CAFO FACILITY INSPECTION REPORT

8335698001 WDID NUMBER	**Ben Slegers** OWNER NAME	**Chino Valley Heifers** FACILITY NAME
CAG018001 NPDES NUMBER	Ex. 6 Personal Privacy (PP) OWNER ADDRESS	FACILITY ADDRESS
R8-2007-0001 RWQCB ORDER NO.	**Bakersfield, CA 93314** OWNER CITY AND STATE	**Corona, CA 92880** FACILITY CITY AND STATE
04/09/2013 SCHEDULED INSPECTION DATE	**Ben Slegers** OWNER CONTACT	**Marty Van Leeuwen** FACILITY CONTACT
04/09/2013 ACTUAL INSPECTION DATE	Ex. 6 Personal Privacy (PP) OWNER PHONE NO.	FACILITY PHONE NO.
Santa Ana River RECEIVING WATER	Ex. 6 Personal Privacy (PP) FACILITY LATITUDE	FACILITY LONGITUDE

Photograph 4. View facing north of accumulated manure in the southwestern corral. Note this corral was vacant.

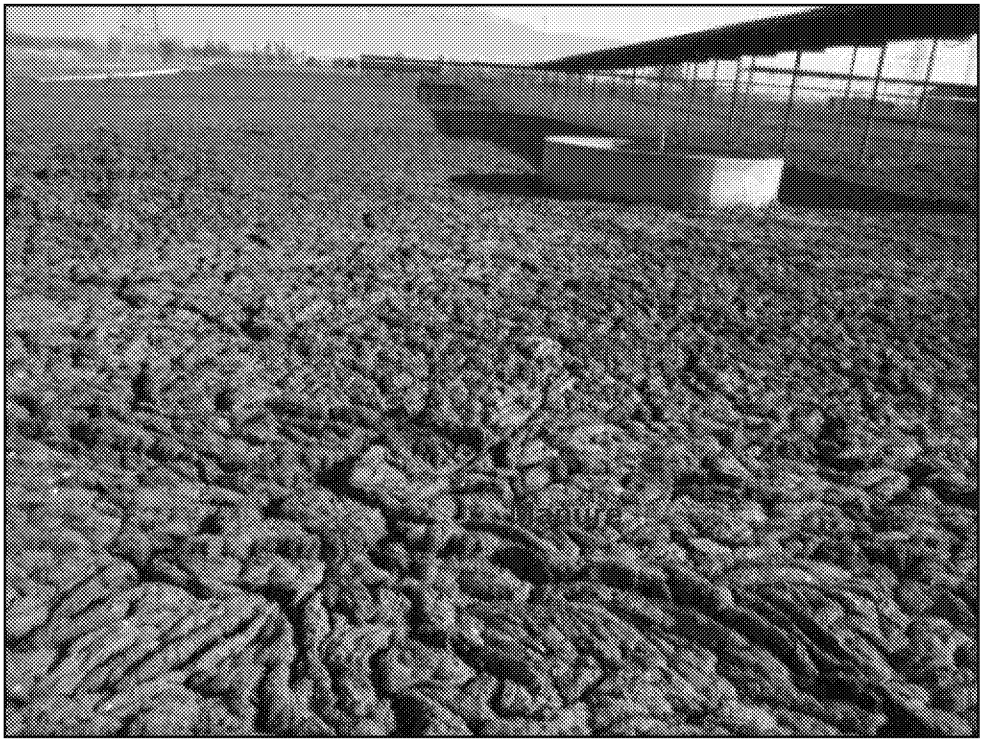
The Facility is a 53-acre heifer ranch with an animal population of approximately 500-800 heifers at the time of the inspection. Mr. Van Leeuwen stated that prior to ending milking operations, process wastewater from the milking barn and wash pen would be piped west, via gravity, into either pond No. 1, located in the central portion of the Facility, or to a disposal field on the west side of the Facility (refer to Photos 9 and 16). It should be noted that the EWMP Site Plan identifies that process wastewater is piped west into pond No. 2, located south of pond No. 1. In addition, he stated that process wastewater had not been land applied onto the disposal field since November 2012. Both pond Nos. 1 and 2 located in the central portion of the Facility, contained process wastewater at the time of the inspection. Pond No.1 was observed with approximately three (3) feet of freeboard (refer to Photos 9 and 10). Pond No. 2 was observed with approximately five (5) feet of freeboard (refer to Photos 11 and 12). Mr. Van Leeuwen stated that process wastewater in the pond was leftover from Chino Valley Dairy No. 2 dairy operations and would be evaporated off. In addition, he stated that the pond Nos. 1 and 2 had not been cleaned since the Discharger took operational control of the Facility on April 22, 2012 due to a lack of maintenance by the previous operator. Furthermore, he stated that the land owner, Richland Homes, was responsible for cleaning the ponds once the Discharger leaves the Facility in July 2013. Pond Nos. 1 and 2 were observed containing accumulated solids and vegetation growth (refer to Photos 9 through 12, and 14 and 15). Depth markers had not been installed in pond Nos. 1 and 2. Surface runoff from all corrals appeared to flow west and pond immediately west of the the corrals (refer to Photos 6, 7, and 8). Fill material and soil stockpiles located between the corrals and ponds appeared to impede corral storm water runoff from flowing west into the ponds (refer to Photo 17). Manure accumulation was observed in the southwestern corral (refer to Photos 4, 5, and 6).

Photograph 9. View facing southwest of pond No. 1 located in the central portion of the Facility. Note vegetation growth was observed on the pond embankments. Also note the pond did not contain a depth marker.

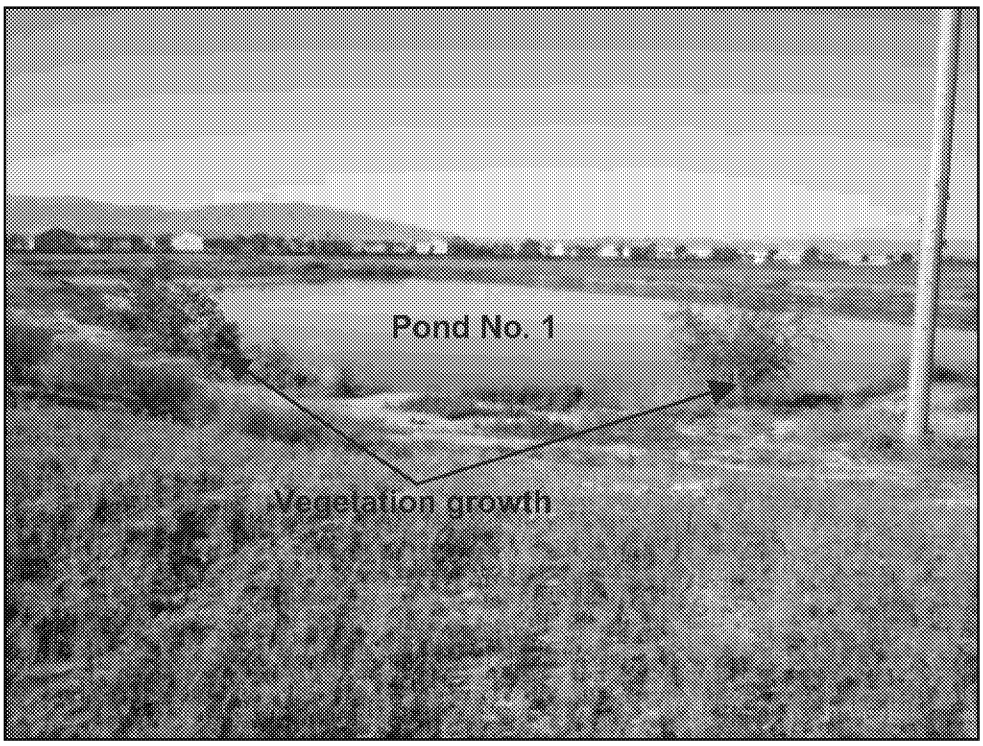
1. Depth markers were not installed in pond Nos. 1 and 2 located in the central portion of the Facility as required by Permit Attachment B - Monitoring and Reporting Program, Section I.B.1 (refer to Photos 9 and 11).

1. The inspector observed, during the inspection, that depth markers had not been not installed in pond Nos. 1 and 2 located in the central portion of the Facility as required by the Permit (refer to Photos 9 and 11). Mr. Van Leeuwen stated that depth markers were not installed in the ponds because depth markers were not present in the ponds when the Discharger took operation control of the Facility on April 22, 2012. Permit Attachment B - Monitoring and Reporting Program, Section I.B.1 states that "a marker shall be placed within each pond or impoundment to indicate the minimum capacity necessary to contain the runoff and direct precipitationof the 25-year, 24-hour rainfall event."

3. The inspector observed, during the inspection, that vegetation growth potentially affecting the containment structure capacity was observed on all pond embankments of pond No. 1 and along the earthen berm between pond Nos. 1 and 2 located in the central portion of the Facility (refer to Photos 9, 10, 14, and 15). Mr. Van Leeuwen stated that the ponds were in poor condition and had not been adequately maintained when the Discharger took operational control of the Facility on April 22, 2012. In addition, he stated that the ponds had not been cleaned or maintained since. As a result, the overall capacity of the containment structures at the Facility may be diminished. Provision VII.C.3.a of the Permit states that "the discharger shall design, construct and maintain containment structures to retain all wastewater within the facility,including all process wastewater and all precipitation on, and drainage through, manured areas resulting from rainfall up to and including a 25-year, 24-hour rainfall event." The Discharger must design and maintain all containment structures per the EWMP as required by Provisions VII.C.3.a of the Permit.

Photograph 12. Close-up view of the accumulated solids in pond No 2, shown in Photograph 11.

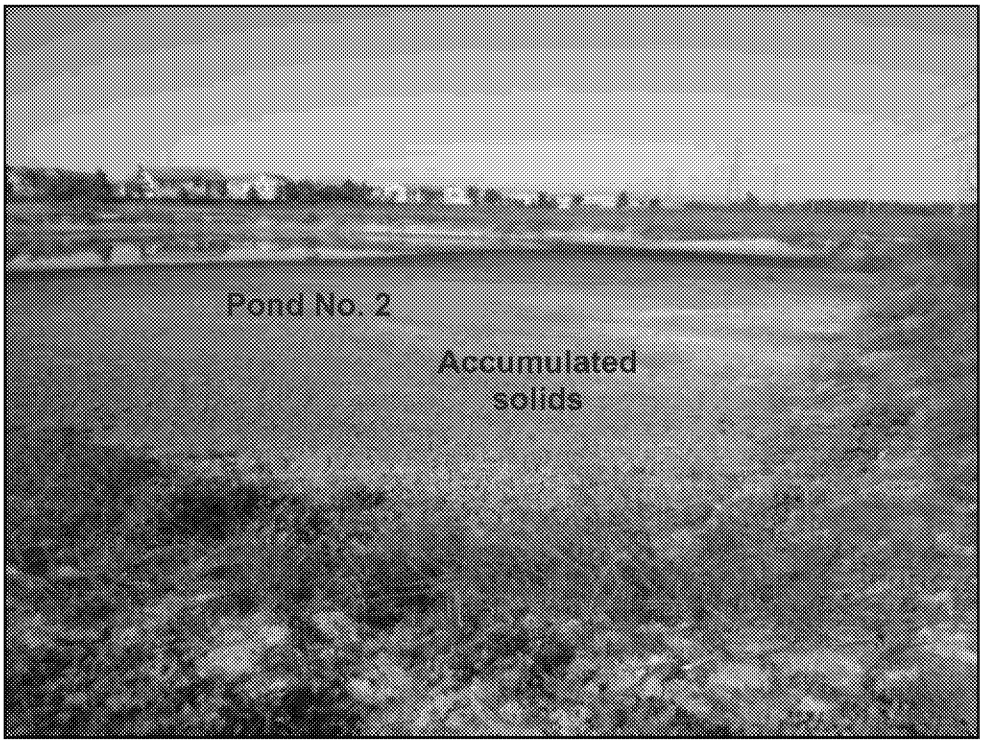
2. The inspector observed, during the inspection, accumulated solids in pond No. 2 in the southcentral portion of the Facility (refer to Photos 11 and 12). Mr. Van Leeuwen stated that the ponds were in poor condition and had not been adequately maintained when the Discharger took operational control of the Facility on April 22, 2012. In addition, he stated that the ponds had not been cleaned or maintained since and most likely would not be cleaned or maintained prior to the Discharger leaving the Facility. Furthermore, he stated that the land owner, Richland Homes, is responsible for cleaning the ponds once the Discharger leaves the Facility in July 2013. As a result, the overall capacity of the containment structures at the Facility may be diminished. Provision VII.C.3.a of the Permit states that "the discharger shall design, construct and maintain containment structures to retain all wastewater within the facility,including all process wastewater and all precipitation on, and drainage through, manured areas resulting from rainfall up to and including a 25-year, 24-hour rainfall event." The Discharger must design and maintain all containment structures per the EWMP as required by Provisions VII.C.3.a of the Permit.

Photograph 14. View facing west of vegetation growth on the earthen berm between pond Nos. 1 and 2 and the process wastewater valve structure location and PVC disposal pipe. Note the PVC disposal pipe was leading to a disposal area not identified in the EWMP or Site Plan (refer to Exhibit 2).

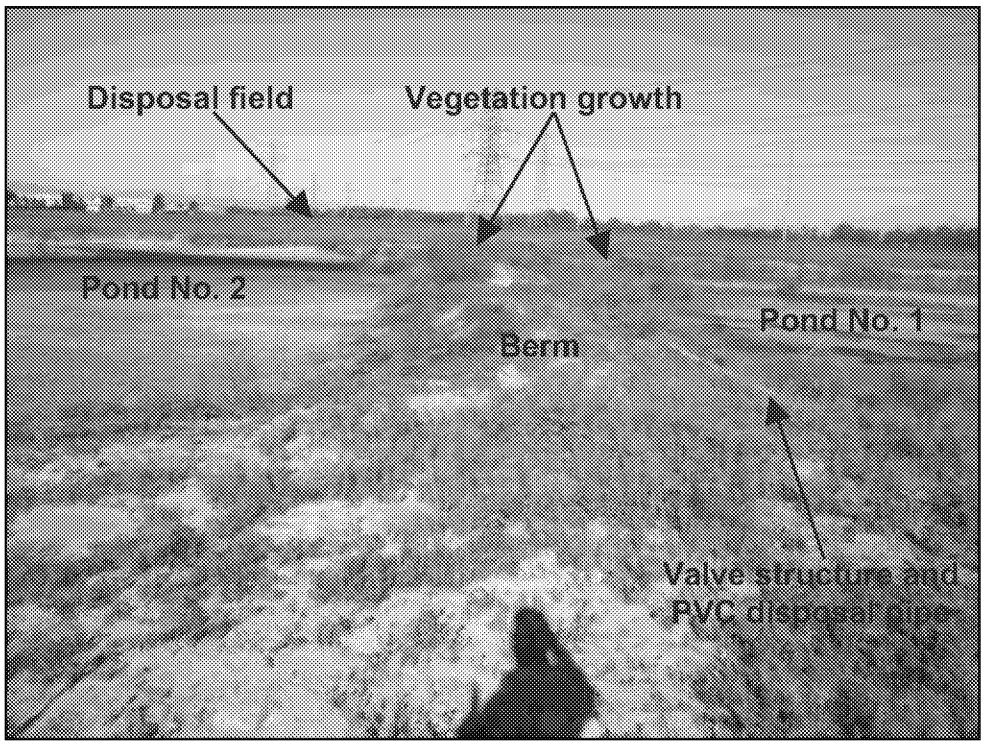
4. The EWMP was not representative of current Facility conditions at the time of the inspection as required by the Permit. Specifically, the EWMP Site Plan identifies process wastewater will be conveyed and land applied via a polyvinyl chloride (PVC) discharge pipe equipped with nine (9) disposal valves along the east side of the field area, located between the corrals and pond Nos. 1 and 2 (refer to Photo 17). A pump, shown in pond No. 2 on the EWMP Site Plan, allows process wastewater "to be reintroduced to the field for additional infiltration," (refer to Exhibit 2). The inspector did not observe a pump in pond No. 2; however, he did observe a PVC pipe from a valve structure adjacent to pond Nos. 1 and 2 extending west across the pond separation berm and into a disposal field west of the ponds (refer to Photos 14 and 15). Mr. Van Leeuwen stated that when the valve is closed, process wastewater is diverted into pond No. 1. The EWMP does not identify a process wastewater disposal field west of the ponds, or identify the conveyance of process wastewater from the valve structure west to the disposal field (refer to Exhibit 2). As a result, the Discharger was not fully implementing the approved EWMP. Provision VII.C.3.b of the Permit states that "the discharger shall develop and fully implement an Engineered Waste Management Plan (EWMP) acceptable to the Executive Officer." The Discharger shall fully implement the EWMP as required by Provision VII.C.3.b of the Permit.

Photograph 17. View facing south of soil stockpiles located between the corrals and the ponds. Note the stockpiles appeared to impede storm water runoff from the corrals from reaching the containment ponds. Also note the EWMP Site Plan identifies this area as a disposal field.

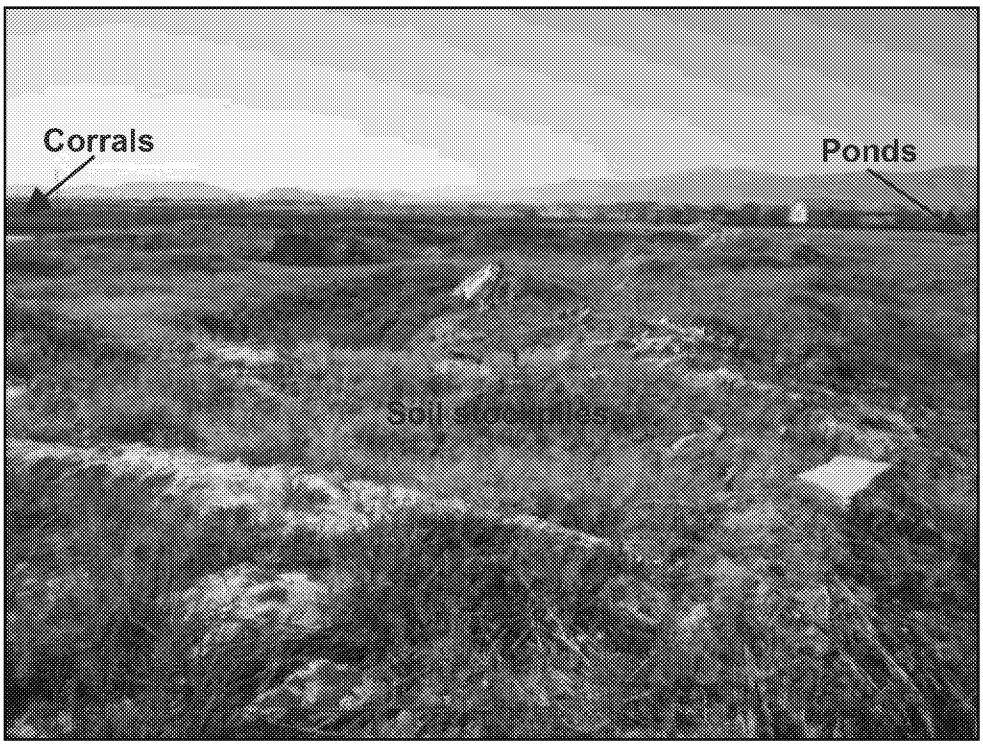
5. Accumulated manure solids located in the soil stockpile area in the central portion of the Facility had not been removed from the Facility within 180 days as required by Provision VII.C.5.e of the Permit (refer to Photos 17, 18, and 19).

1. The inspector observed, during the inspection, that accumulated manure solids were present in the soil stockpile area located in the central portion of the Facility, west of the corrals (refer to Photos 17, 18, and 19). Mr. Van

Leeuwen stated that the soil stockpile area and manure was left over from the previous operator. It appeared to the inspector that the soil stockpile area was leftover material from the eight (8) containment structures that were previously installed at the Facility. The manure solids appeared to be at the bottom of a previous containment structure. As a result, the manure solids had not been removed from the Facility within 180 days as required by Provision VII.C.5.e of the Permit.
